Project	IEEE 802.16 Broadband Wireless Access Working Group < http://ieee802.org/16 >	
Title	Privacy key management for BSs and BSISs in 802.16 LE Systems	
Date Submitted	2005-09-13	
Source(s)	Hung-Lin Chou, Chi-Chen Lee, Industrial Technology Research Institute, Computer and Communications Research Labs, Taiwan Bldg. 11, 195 Sec. 4, Chung Hsing Rd. Chutung, HsinChu, Taiwan 310, R.O.C.	Voice: +886-3-5912042 Fax: +886-3-5829733 mailto: hunglinchou@itri.org.tw
Re:	Call for Contributions, IEEE 802.16h Task Group on License-Exempt Coexistence, IEEE 802.16h-05/014, 2005/06/09	
Abstract	Propose the PKM protocol for intercommunications in 802.16 LE.	
Purpose	Information.	
Notice	This document has been prepared to assist IEEE 802.16. It is offered as a basis for discussion and is not binding on the contributing individual(s) or organization(s). The material in this document is subject to change in form and content after further study. The contributor(s) reserve(s) the right to add, amend or withdraw material contained herein.

Privacy Key Management for BSs and BSISs in 802.16 LE Systems

Hung-Lin Chou, Chi-Chen Lee
Computer & Communications Research Labs, ITRI, Taiwan

Figure 1 BSs/BSISs connection encrypted in IPsec

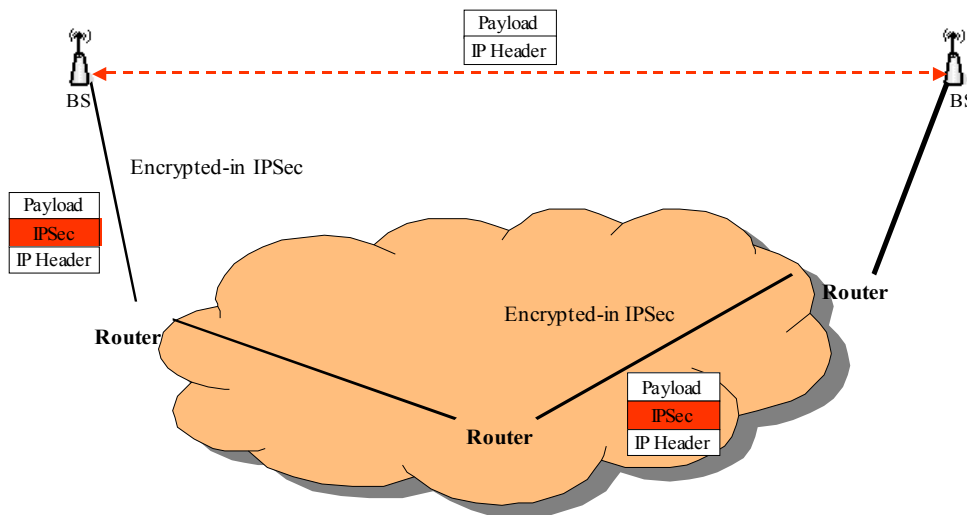
[insert the following section into 2.1.2.1 Architecture]

Considering the IP network firewalls and different filtering rules, we should find a common security solution to make BSs/BSISs data connection transparent under almost common network management cases. IPsec is used to IPv4 and also included in IPv6 for the IP-Layer security solution. And all BSs/BSISs don't just reside in the same network environment. The data connections should go through some routers/firewalls and need to follow a common security rules.

Figure 1 shows the BSs/BSISs connections encrypted in IPsec. Based on IPsec, all data connections between BSs/BSISs could pass through firewalls and routers unless some firewalls block IPsec connections.

Figure 2 Network Architecture under multi-Operators with multi-RADIUS Servers

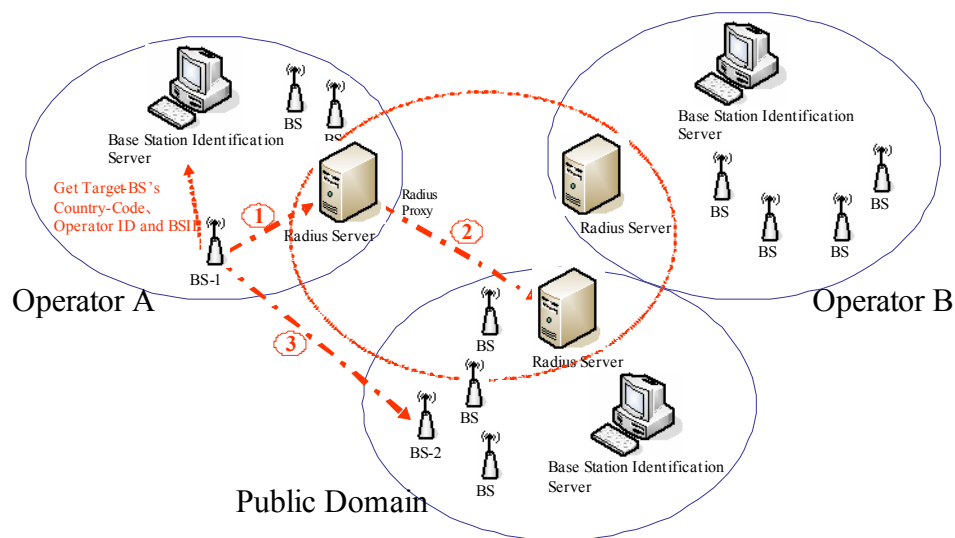
Figure 2 demonstrates the IEEE 802.16 LE inter-network communication architecture under multi-Operators with multi-RADIUS Servers.

If BS-1 wants to communicate with BS-2, it must get BS-2's Country's Code, Operator ID and BSID from local BSIS first. And then work as the following steps

- (1) BS-1 send RADIUS-Access-Request frame with BS-2's Country's Code, Operator ID and BSID to local RADIUS-Server
- (2) Local RADIUS-Server will act as RADIUS-Proxy and transfer this RADIUS-Access-Request to the target RADIUS-Server
- (3) Target RADIUS-Server will response RADIUS-Access-Accept with Pairwise-Master-Key and PMK-index for BS-1 and Security-Block for BS-2
- (4) Local RADIUS-Server will generate Security-Block including Pairwise-Master-Key and PMK-index from target RADIUS-Server

- (5) BS-1 will receive RADIUS-Access-Accept from its local RADIUS-Server and get the Pairwise-Master-Key, PMK-index and ESP Authentication/Transform IDs in Security-Block for BS-1
- (6) BS-1 will act as a PKM-initiator to send Session-Key-Start to BS-2 with Security-Block for BS-2
- (7) BS-2 will calculate the ESP-Key-Stuffs with Pairwise-Master-Key, choose the ESP Authentication/Transform IDs supported by BS-2 and response Session-Key-Request to BS-1
- (8) BS-1 will also calculate the ESP-Key-Stuffs with Pairwise-Master-Key to verify Key-Signature, compare ESP Authentication/Transform IDs support by BS-2 with current settings supported by BS-1 and response Session-Key-Response to BS-2
- (9) BS-2 will verify Key-Signature and response Session-Key-Accept to BS-1
- (10) After the above procedures, BS-1 and BS-2 could communicate in IPsec with the ESP-Key-Stuffs generated dynamically

Figure 3 Network Hierarchy for RADIUS-Servers

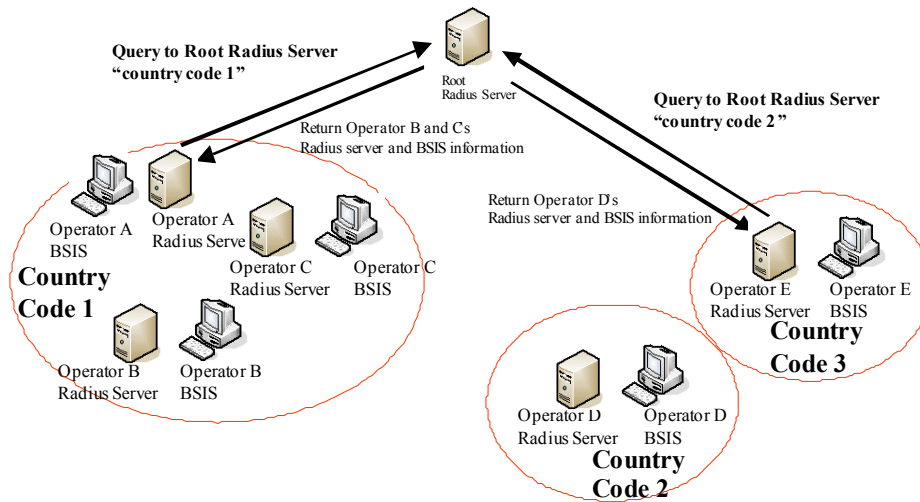
The following figure shows the IEEE 802.16 LE Network Hierarchy for RADIUS-Servers to find another RADIUS Servers via the Root-RADIUS-Server by the Country Code.

For the IEEE 802.16 LE, we want it to work with multi-RADIUS-Servers, but how to find each RADIUS-Server near local RADIUS-Server would be a critical issue. The Root-RADIUS-Server will play a Key-Role for each RADIUS-Server to find the RADIUS-Servers in the near countries by Country-Codes. Based on this mechanism, each RADIUS-Server need to keep shared-key with the Root-RADIUS-Server and use the RADIUS-Access-Request frame to request the target Country-Code's RADIUS-Servers information. The Root-RADIUS-Server will response those information in RADIUS-Access-Accept frame. The response information will include Operators' RADIUS-Servers and BSISs information of the target Country-Code.

Figure 4 Individual Session-Key

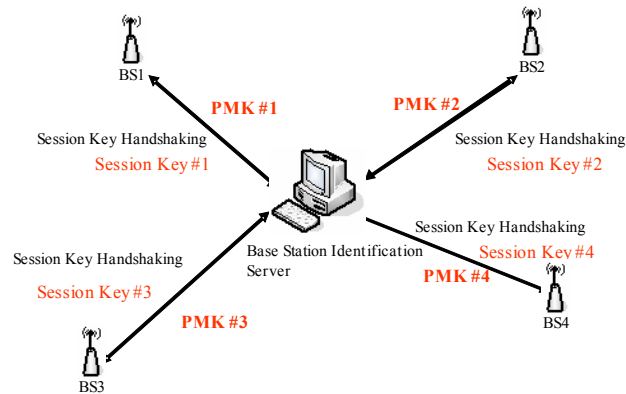
The following figure shows the each connection of BSs/BSISs will be encrypted in individual Session-Key in IPsec

For the BSs/BSISs, each connection with different BSs/BSISs will use individual Session-Key in IPsec. Those Session Keys would be generated from PKM-Handshaking with Pairwise-Master-Keys between each pair BSs/BSISs. The re-key procedures also don't need RADIUS-Servers and just use Pairwise-Master-Keys.

Figure 5 RADIUS protocol example

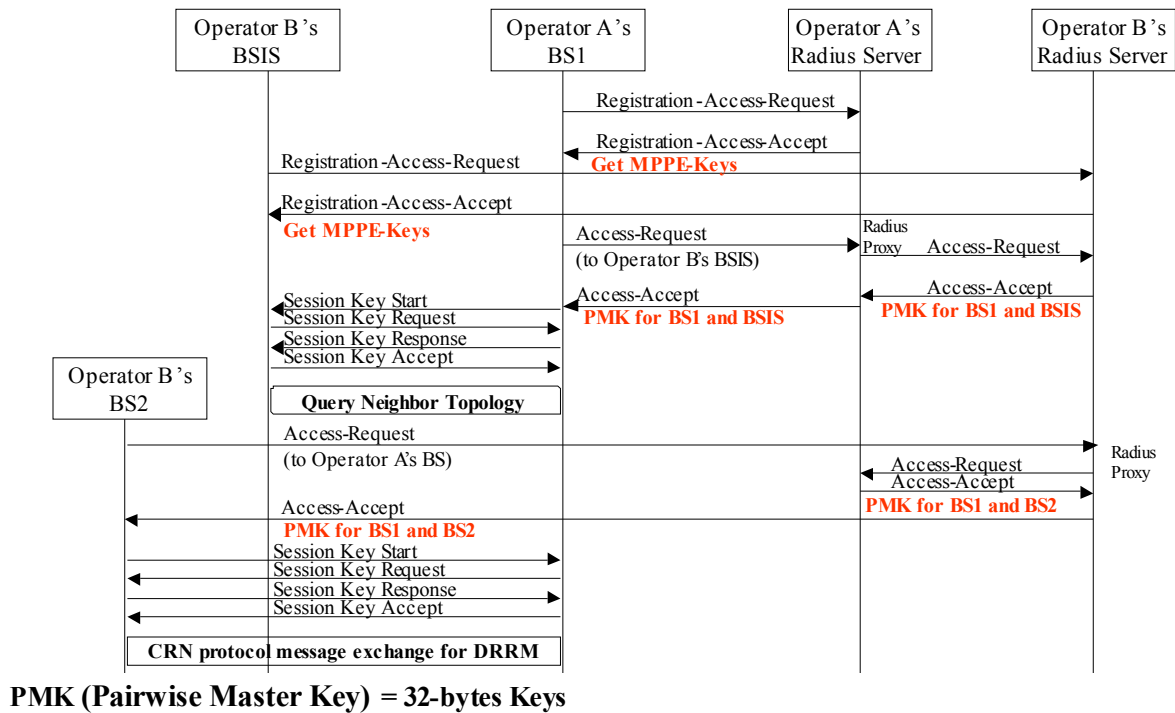
[replace section 3.2.4.2 with the following]

Figure 5 shows the RADIUS protocol message exchange sequence. At starting up, each BS or BSIS must send a RADIUS-BS/BSIS-Registration-Access-Request (shown in table 2) to the RADIUS server for authentication purpose and leave the address mapping (BSID to IP) information in the server. At this time, the RADIUS server will retain the following information of registered BS or BSIS:

- (a) Wireless medium address of BS (BSID) or medium address of BSIS,
- (b) MPPE-Keys in RADIUS-BS/BSIS-Registration-Access-Request/Accept Procedures
- (c) IP address or DNS name,
- (d) Cipher suites supported by the BS or BSIS for the protection of Coexistence Protocol communications,
- (e) and Pairwise-Master-Key for BS or BSIS to establish Session-Key-Handshaking procedures

Figure 6 PKM Session-Key-Handshaking procedures

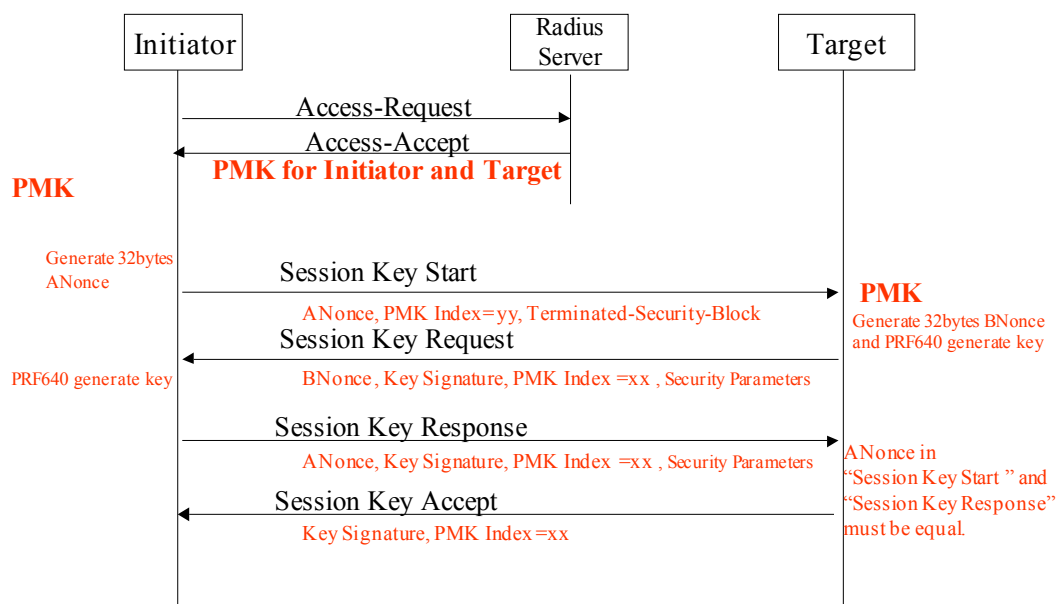
[insert the following section into 3.2.4.4 Privacy Key Management protocol usage]

The following figure shows the PKM Session-Key-Handshaking procedures

The PKM-Initiator will need to get the Pairwise-Master Key in Originated-BS-Security-Block from RADIUS-Server. And then perform the following steps

- (1) PKM-Initiator would get Pairwise-Master-Key-Index, Pairwise -Master-Key, ESP Authentication/Transform IDs and Key-Lifetime in originated Security-Block in RADIUS-BS/BSIS-Access-Accept message and then generate a random 32-bytes ANonce.
- (2) PKM-Initiator would will send Session-Key-Start message to PKM-Target with "ANonce", "Pairwise-Master-Key-Index" and "Terminated Security-Block".

- (3) After receiving Session-Key-Start message, PKM-Target would generate a random 32-bytes BNonce. And perform the PRF640 algorithm to generate the 640-bits Key. Keep the first 512-bits ESP-Transform/Authentication Keys and use the last 128-bits M-Key as the HMAC-MD5 key to generate 16-bytes Key-Signature.

- (4) PKM-Target would will send Session-Key-Request message to PKM-Initiator with “BNonce”, ”Pairwise-Master-Key-Index” and ” ESP Authentication/Transform IDs”(PKM-Target chosen).

- (5) After receiving Session-Key-Request message, PKM-Initiator would perform the PRF640 algorithm to generate the 640-bits Key. Keep the first 512-bits ESP-Transform/Authentication Keys and use the last 128-bits M-Key as the HMAC-MD5 key to generate 16-bytes Key-Signature to verify the Key-Signature field on the Session-Key-Request message. If it is wrong, PKM-Initiator would perform silent-drop and doesn't response any message. If it is correct, PKM-Initiator would prepare the Session-Key-Response message and use HMAC-MD5 generate Key-Signature filed.

- (6) PKM-Initiator would will send Session-Key-Response message to PKM-Target with “ANonce”, ”Pairwise-Master-Key-Index” and ” ESP Authentication/Transform IDs”(PKM-Initiator chosen) .

- (7) After receiving Session-Key- Response message, PKM-Target would check the ANonce value if equal to the previous ANonce value in Session-Key-Start message and use HMAC-MD5 generate Key-Signature filed to verify the Key-Signature field. Compare the values of ”ESP Authentication/Transform IDs” to make sure the security parameters.

- (8) After the above, PKM-Target will send Session-Key-Accept with Key-Signature filed to PKM-Initiator to verify.
- (9) The following IPsec connection will use the first 512-bits ESP-Transform/Authentication Keys from PRF640 as keys and perform the ESP-Transform/Authentication algorithms from chosen ESP Authentication/Transform IDs.

Figure 7 PKM Session-Key Re-Key procedures

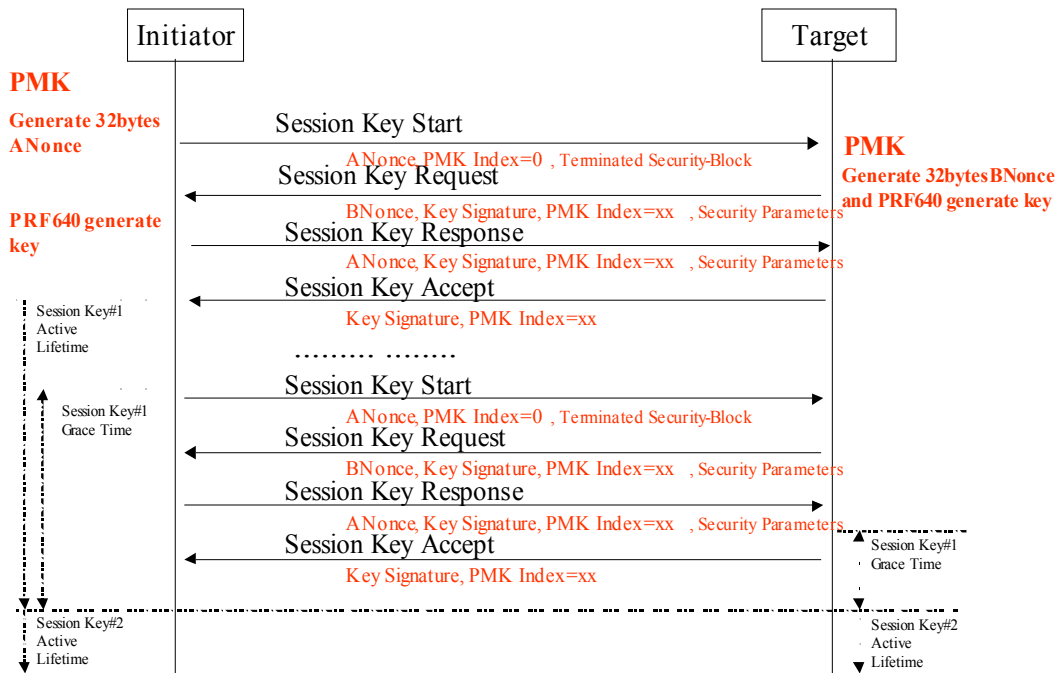
The following figure shows the PKM Session-Key Re-Key procedures

Each Session-Key would set a Key-Lifetime, and PKM-Initiator could set a Session-Key grace time to perform Session-Key-Handshaking for the next new Session-Key#2 to be generated until the end of the key lifetime. The Session-Key#1 could use up its lifetime and then activate the Session-Key#2. If each side use the Session-Key#2 first in IPsec connection, it could also activate the Session-Key#2. If the lifetime of Session-Key#1 use up, the PKM-Initiator doesn't perform the Session-Key Re-Key procedures. PKM-Target would disconnect the IP connection until the Session-Key#2 generated.

Figure 8 PKM Session-Key Re-Key procedures with the MK update of PKM-Target

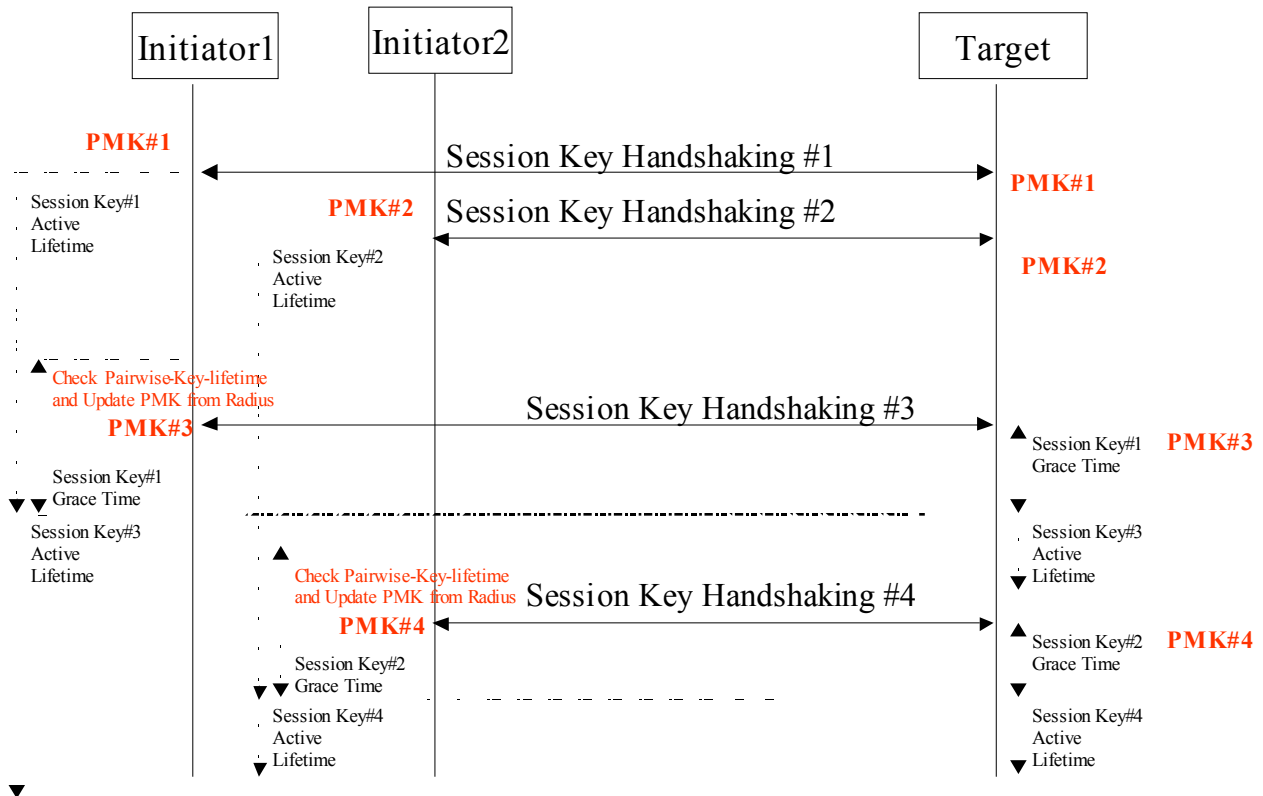
The following figure shows the PKM Session-Key Re-Key procedures with the PMK update

The PKM-Initiator will check the current Pairwise-Key-Lifetime if still valid. If the PKM-Initiator detects the Pairwise-Key-Lifetime used up, it would perform RADIUS-BS/BSIS- Access-Request/Accept procedures to get the latest Pairwise-Master-Key in Security-Blocks from RADIUS-Server.

Each Pairwise-Master-Key would set a Pairwise-Master-Key-Lifetime, and BSs/BSISs could set a Pairwise-Master-Key grace time to perform Access-Request/Accept procedures for the new Pairwise-Master-Key until the end of the Pairwise-Master-Key lifetime. If the lifetime of Pairwise-Master-Key use up, the originated

BSs/BSISs don't perform the Access-Request/Accept procedures, the terminated BSs/BSISs should discard the connections.

Figure 9 the 640-bits Key generated by PRF640

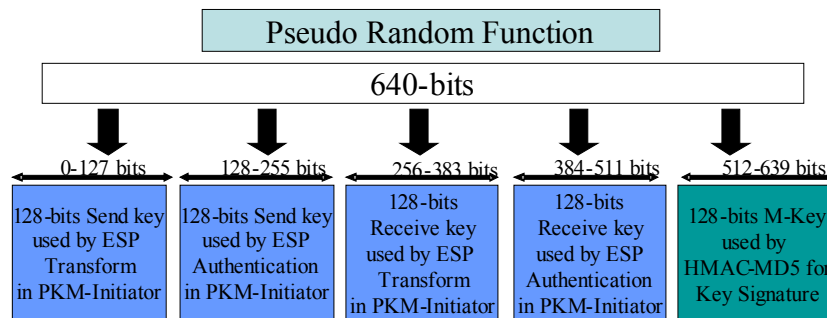
The following figure shows the 640-bits Key generated by PRF640

The BSs/BSISs get Pairwise-Master-Key from RADIUS-Servers and generate 32-bytes Nonce value to derive 640-bits key as follows

PRF-640(PMK, "BS-BSIS key expansion", Min(BS1ID,BS2ID) || Max (BS1ID,BS2ID)|| Min (ANonce,BNonce) || Max(ANonce,BNonce))
